**CERTIFICATE OF APPROPRIATENESS**

**Property:** 811 Hemphill Street, Tract 7, Block 396, Baker W R NSBB Subdivision. The property includes a historic 784 square foot, one-story wood frame single-family residence situated on a 2,069 square foot interior lot.

**Proposal:** Alteration – Construct two sets of front steps (a set on either side of the porch)

**PROPOSED STEPS**

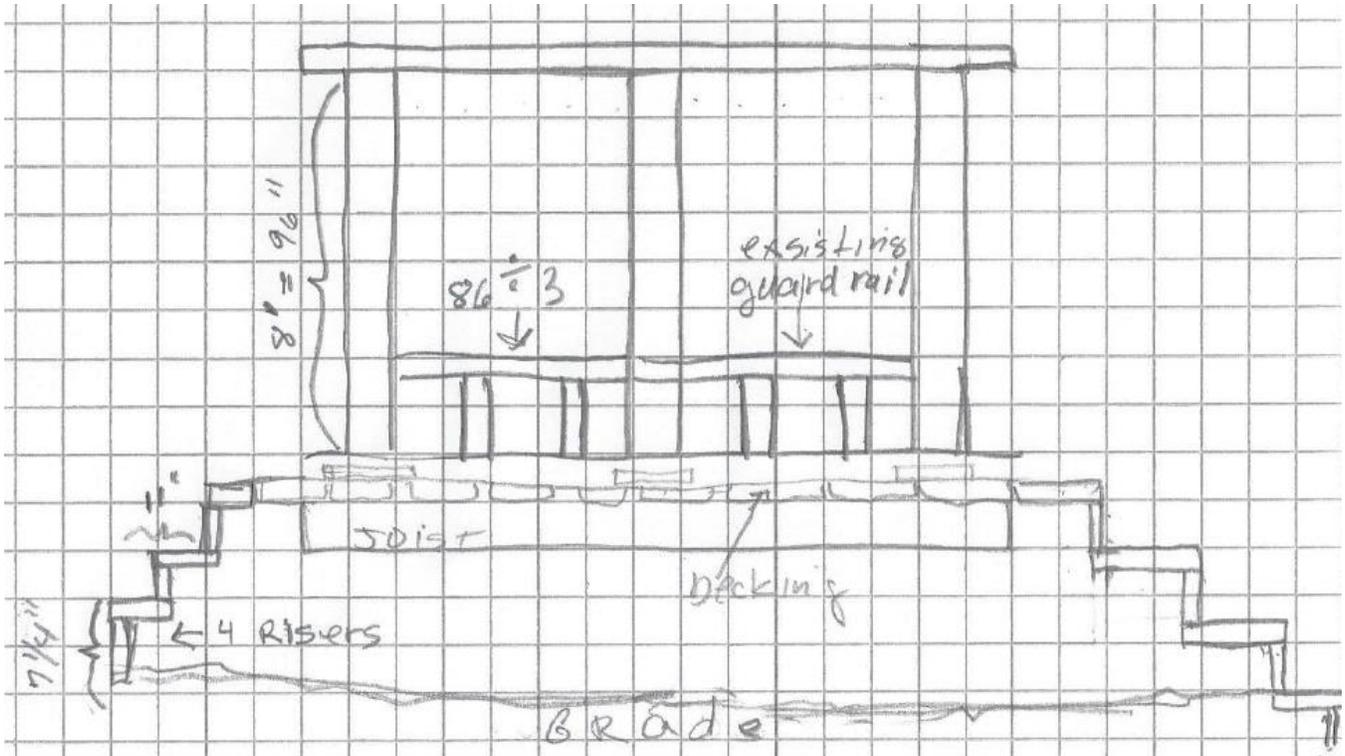
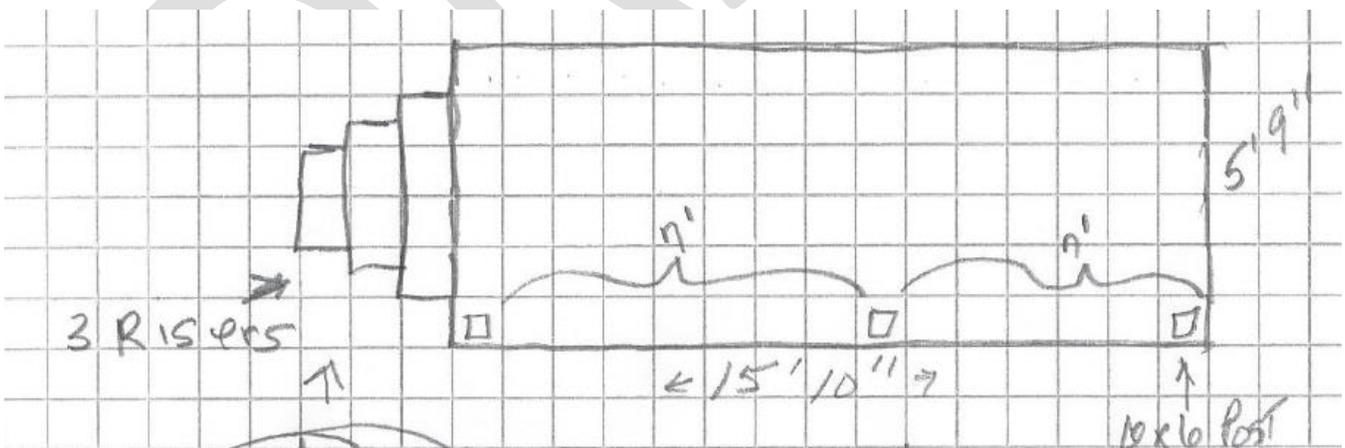
The applicant proposes to construct a new set of steps that meets the required code. Each tread will be 11" in depth and each riser will be 7¼" in height. As proposed, the steps are four risers high and require a handrail; the handrail will need to meet code requirements. The handrail will be a 34" in height and will include a balustrade (intermediate rails) spaced no more than 4" apart. The proposed stairs and handrail will meet City of Houston Building Code. The existing guardrail, porch columns, porch flooring and roof is to remain. See drawings and photos for more detail.

311 REPORT PHOTO

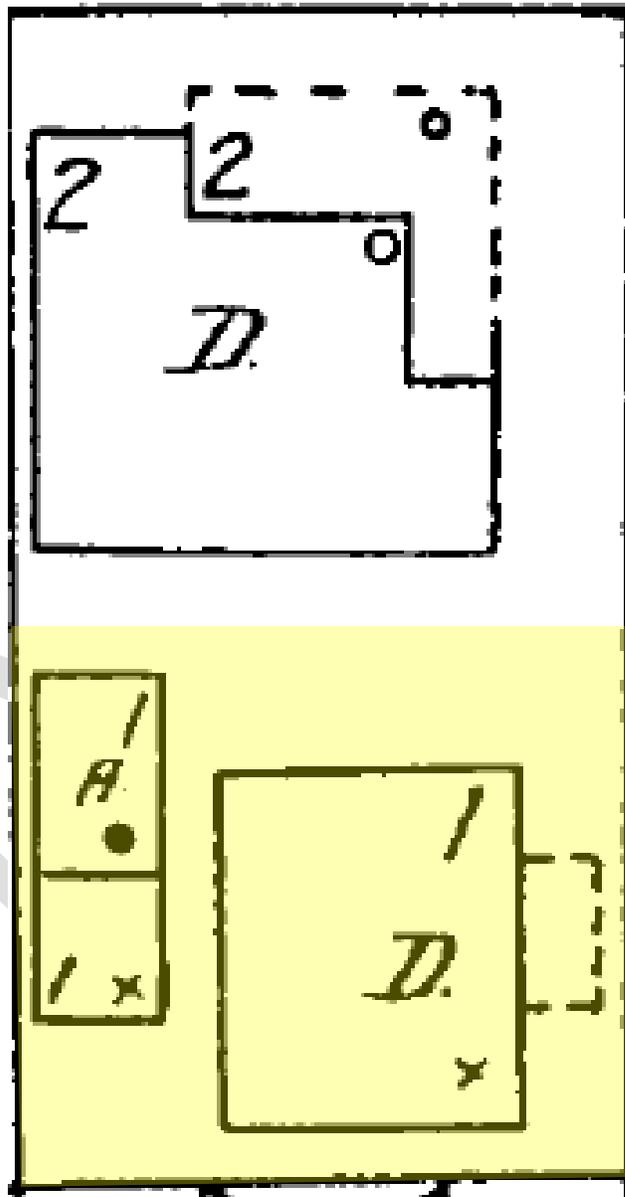
A Red Tag was issued on February 23, 2016, for doing work without a permit and to obtain all necessary permits.

A second follow up Red Tag was issued on March 8, 2016.
